Re: **Docket No. 536 – Tarpon Towers III, LLC and Cellco Partnership d/b/a Verizon Wireless application for a Certificate of Environmental Compatibility and Public Need for the construction, maintenance and operation of a telecommunications facility located at 78 Goshen East Street in Norfolk, Connecticut**

RESPONSES OF TARPON TOWERS III, LLC AND CELLCO PARTNERSHIP D/B/A  
VERIZON WIRELESS TO  
CONNECTICUT SITING COUNCIL INTERROGATORIES

# **EXHIBIT 1**

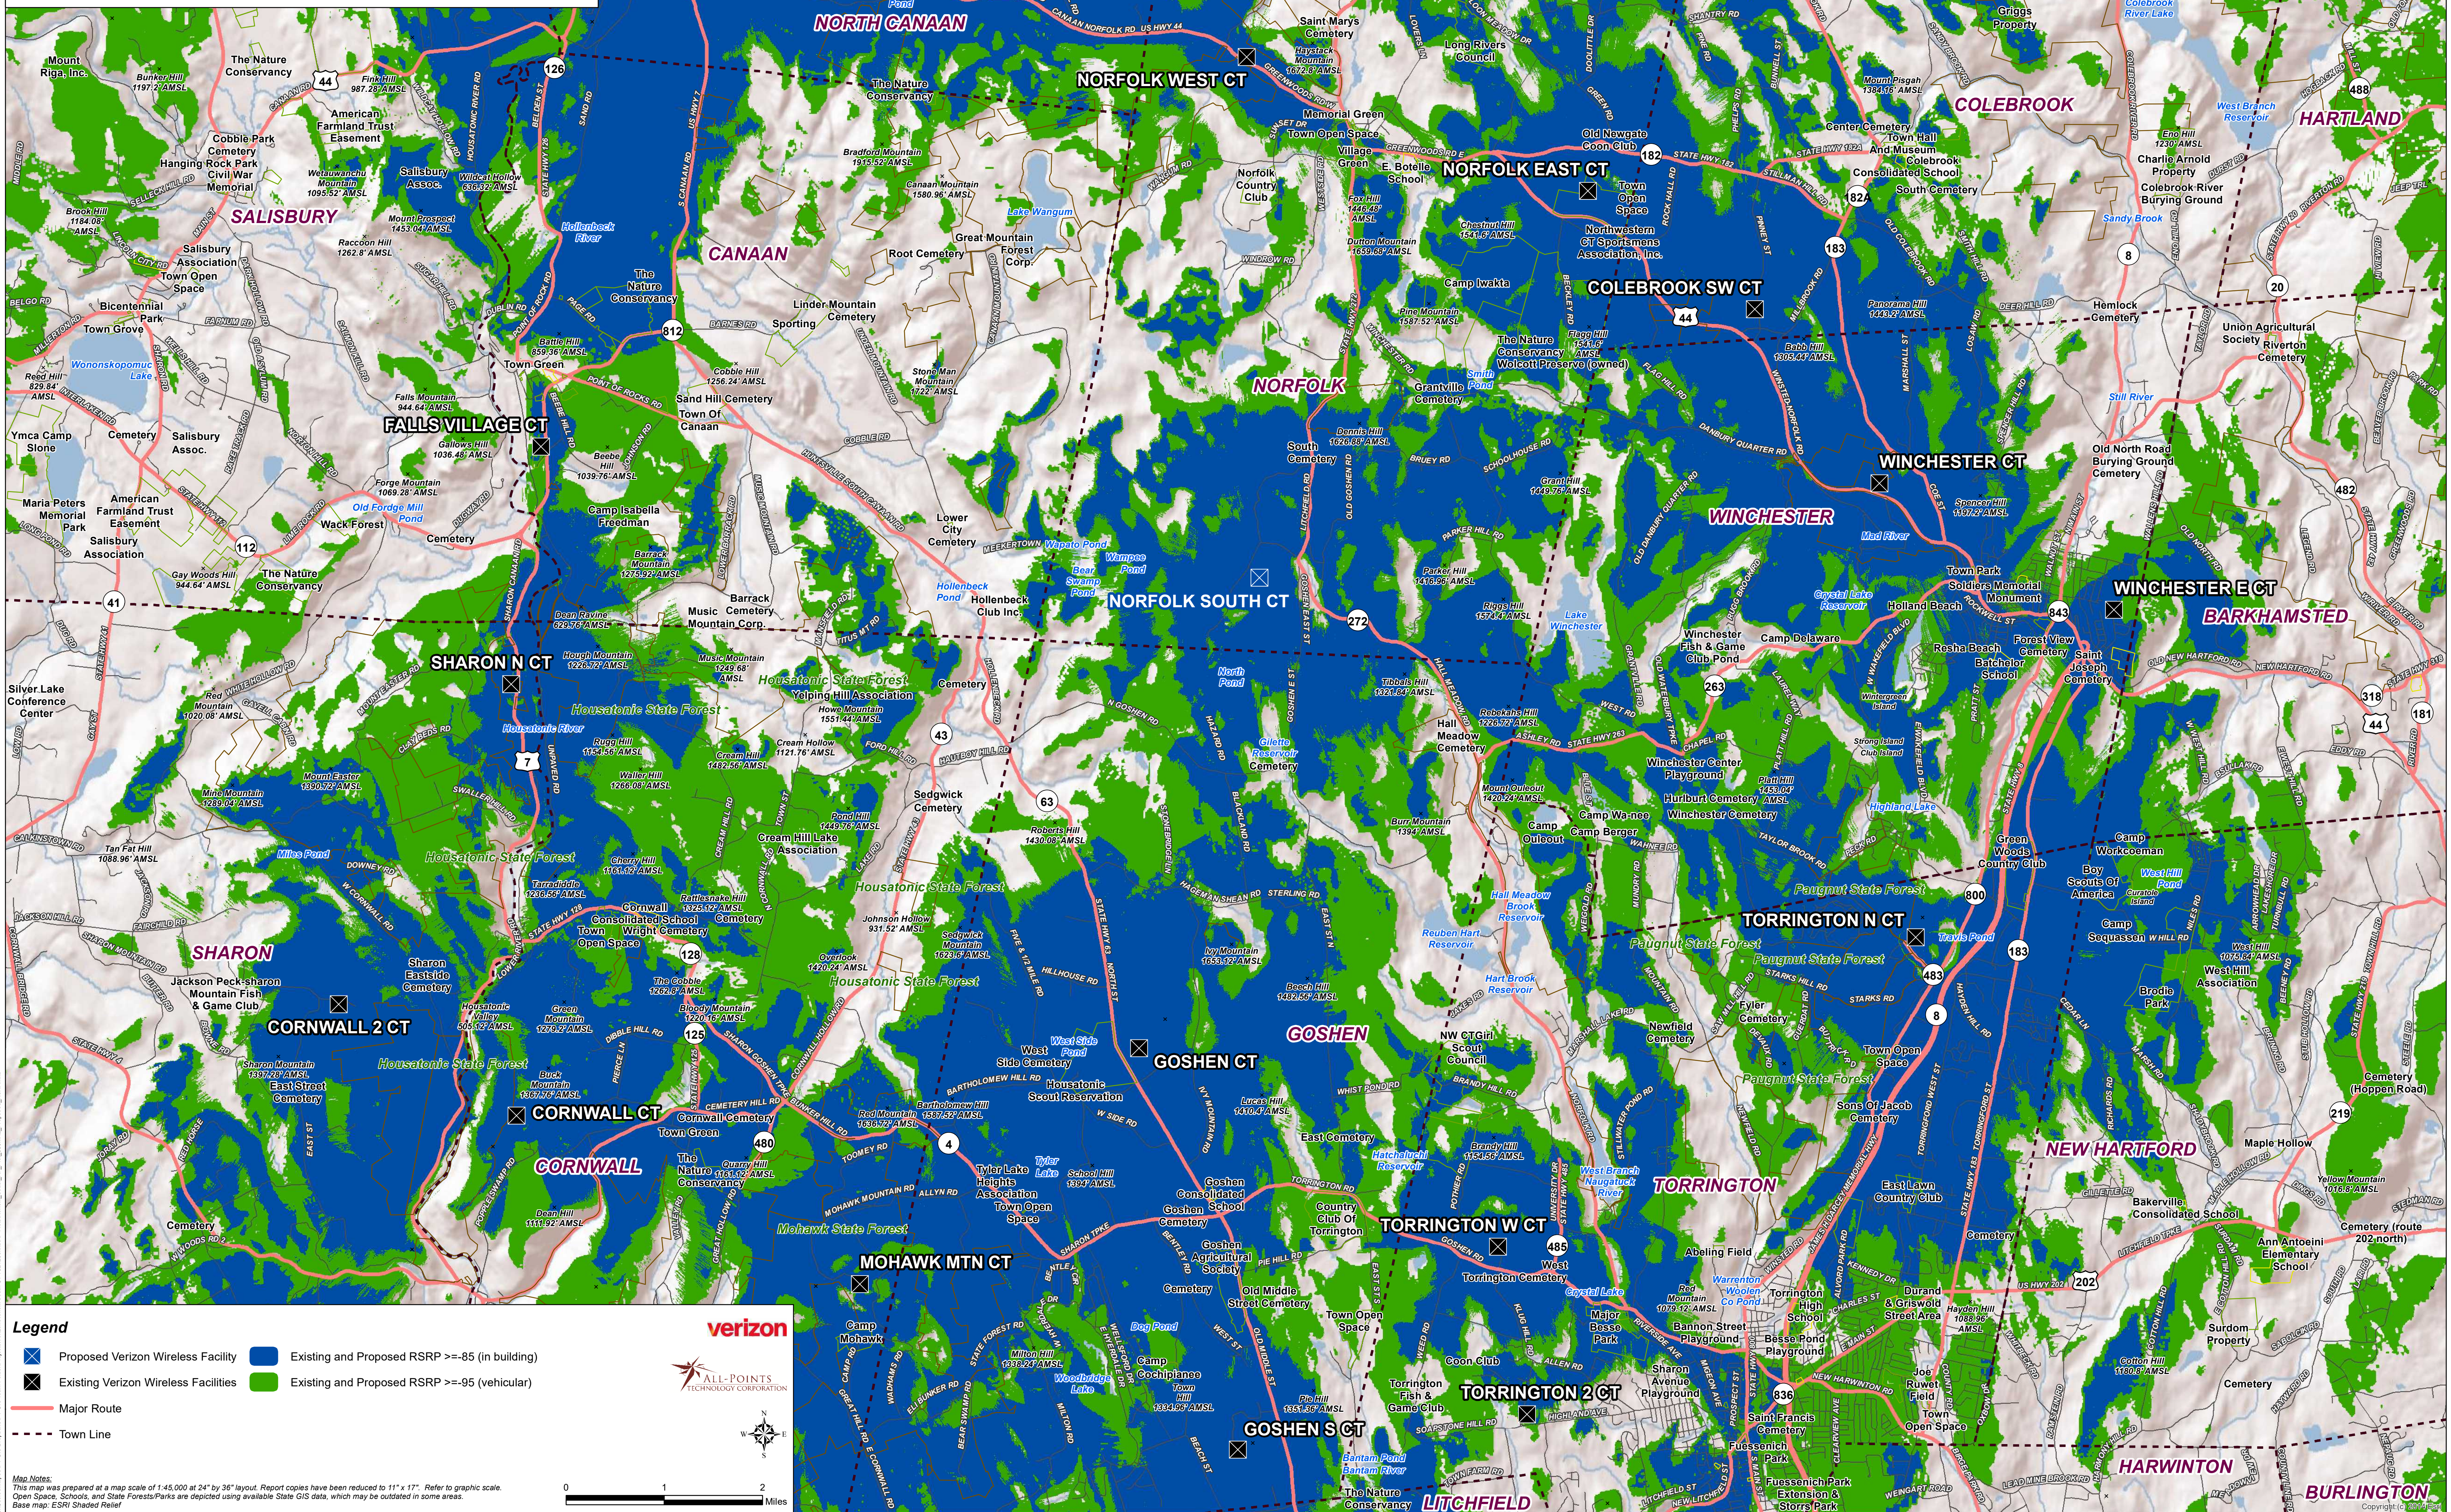
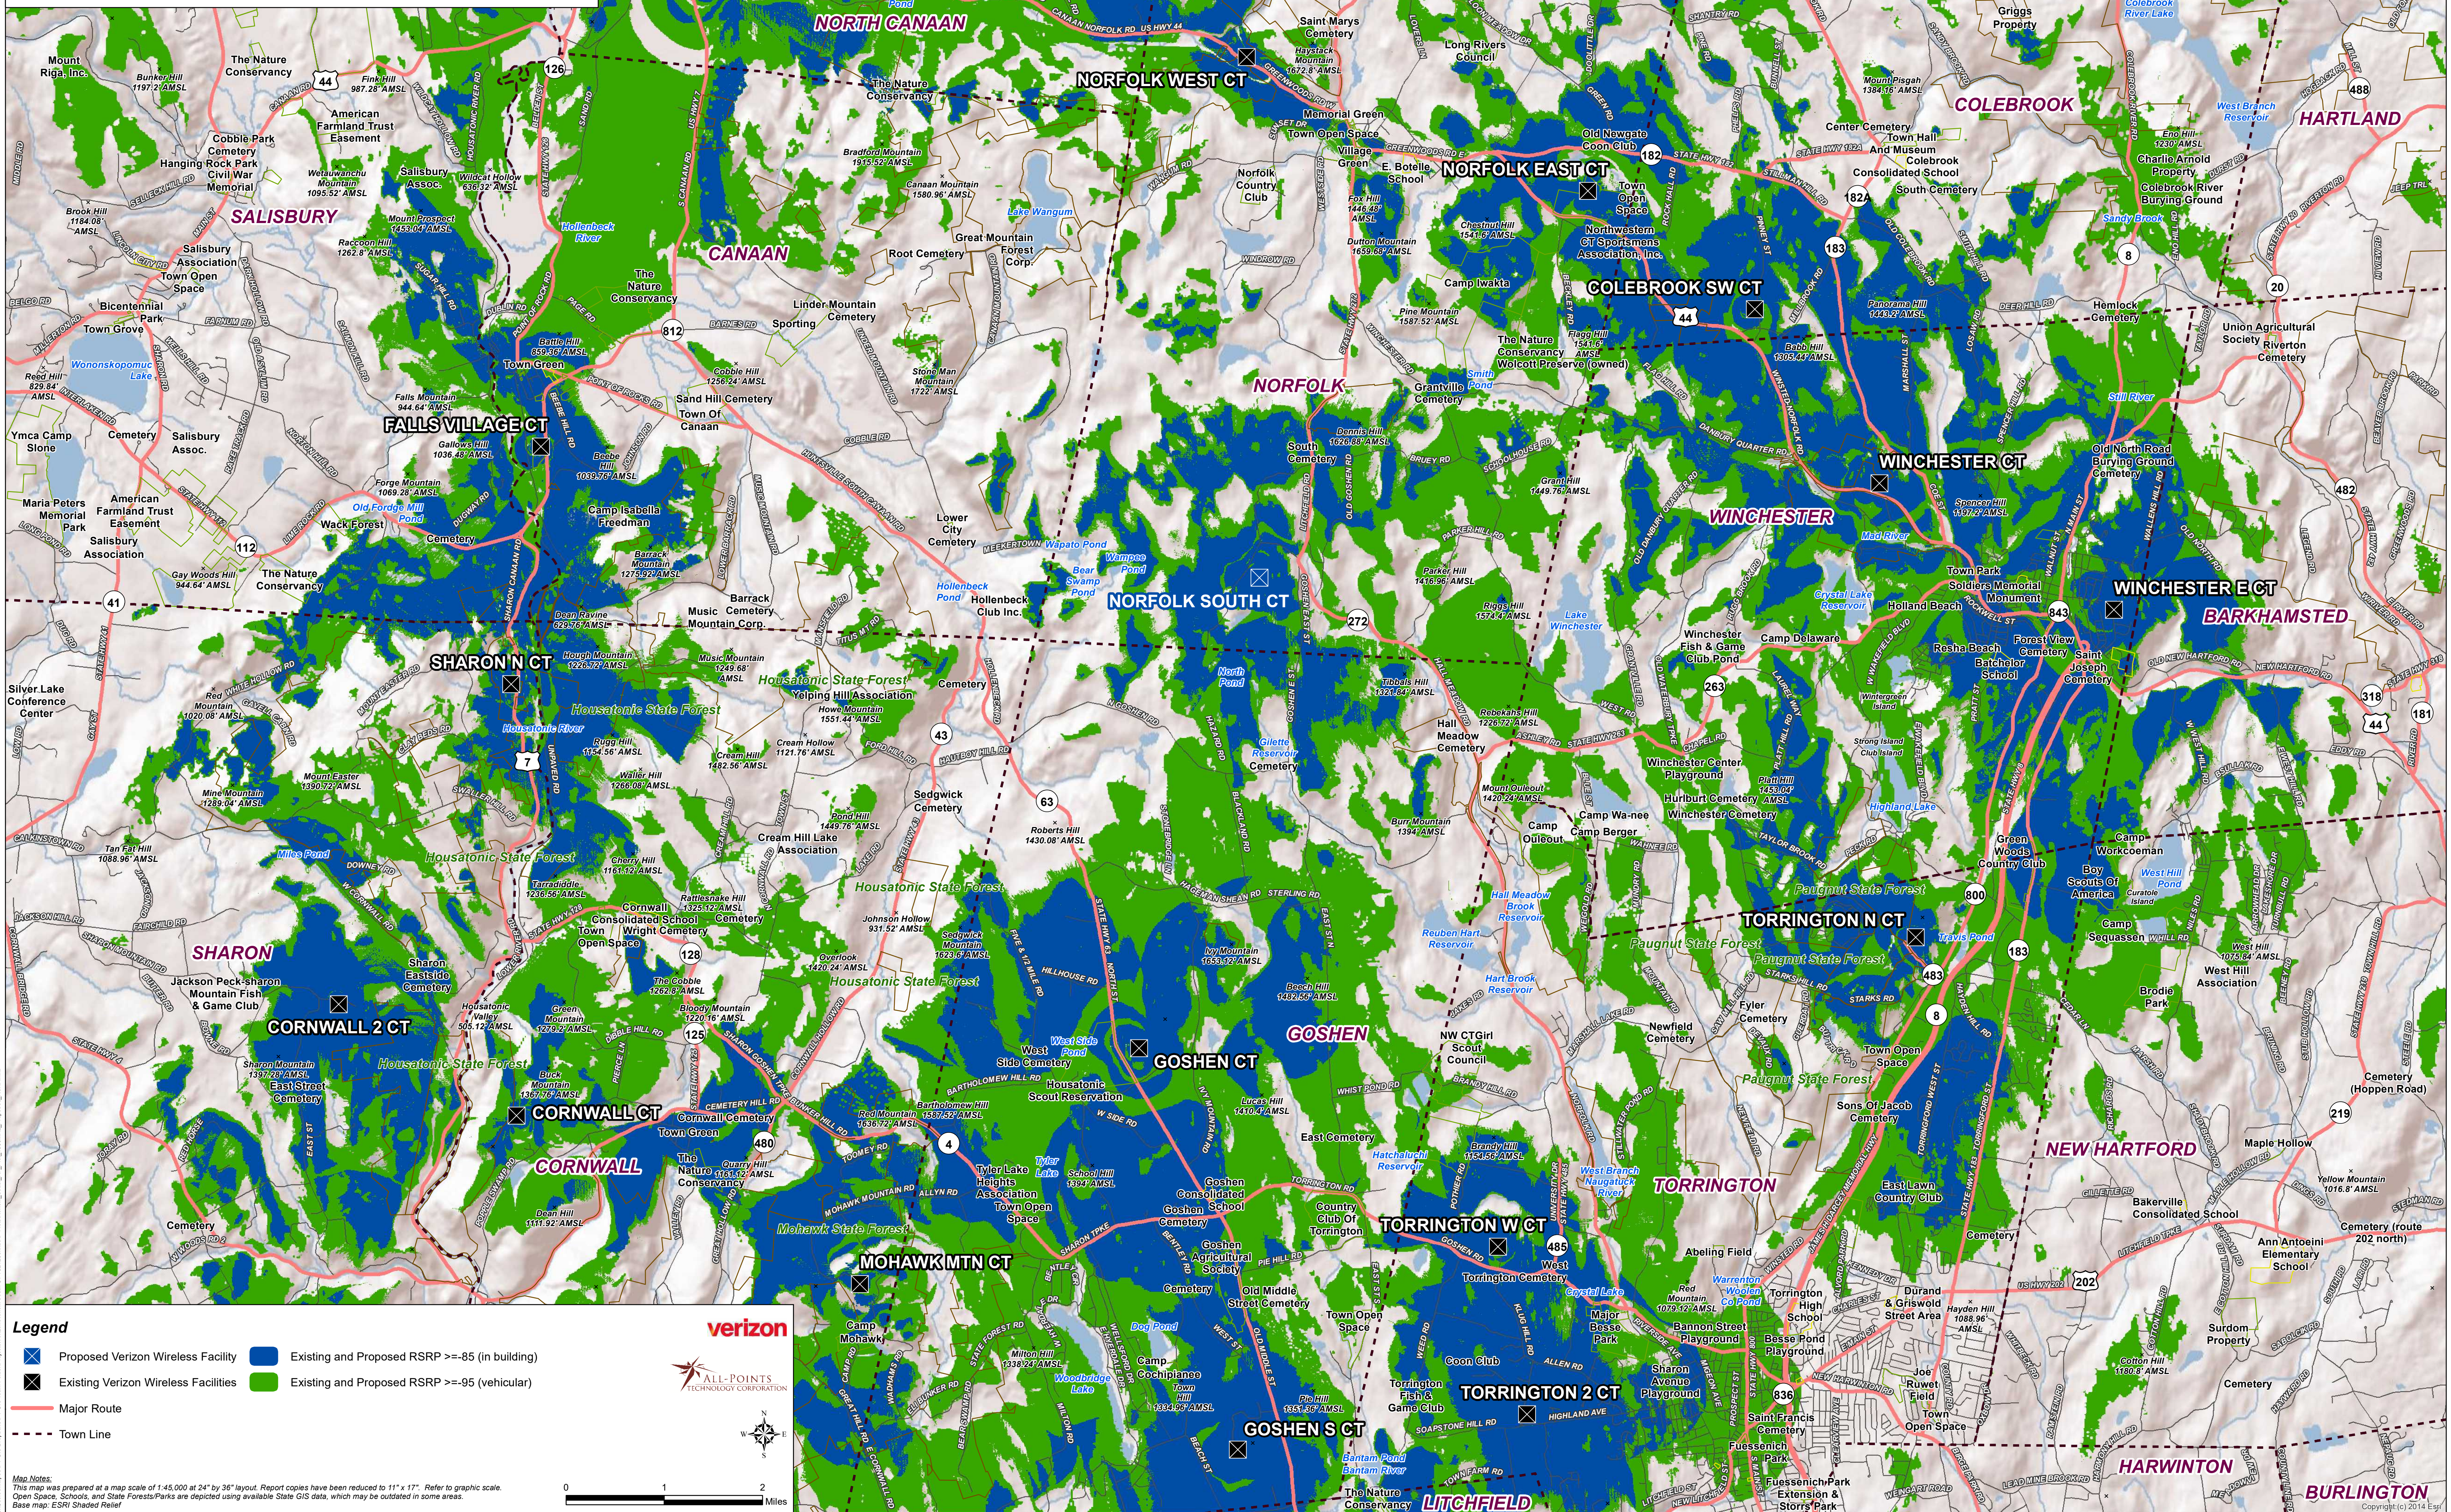
Referencing Application p. 8, what is the length of the service gaps on Routes 272 and 263?

In preparation for these interrogatories, discrepancies were noted in the coverage maps in Application Attachment 6 that appear to have overpredicted proposed service from the proposed Norfolk South Facility and the existing facilities in the area due to the inclusion of service at -105 dBm signal level. As the Council is aware, and as noted in response to Question No. 20 above, the -105 dBm signal level does not meet Cellco’s service reliability standard. The existing

and proposed coverage maps attached hereto as Exhibit 1 (Modified Existing and Proposed Coverage Maps) have been adjusted to show -85 dBm and -95 dBm signal levels from the proposed Norfolk South Facility and the existing facilities in the area. The responses to these interrogatories correspond directly to those modified existing and proposed coverage plots. No modifications to the “existing coverage” plots provided in Attachment 6 in the Application were required.

The existing gap in Cellco service along Route 272 is approximately 4.9 miles in the Norfolk and approximately 2.1 in Goshen. If approved, the Norfolk South Facility will fill the entire 4.9-mile gap in Norfolk and a 0.3-mile portion of the gap in Goshen.

The existing gaps in Cellco service along Route 263 consists of approximately 0.4 miles in Goshen and approximately 3.0 miles in Winchester. If approved, the Norfolk South Facility will fill a 0.3 mile portion of the gap in Goshen and approximately 2.3 mile portion of the gap in Winchester.
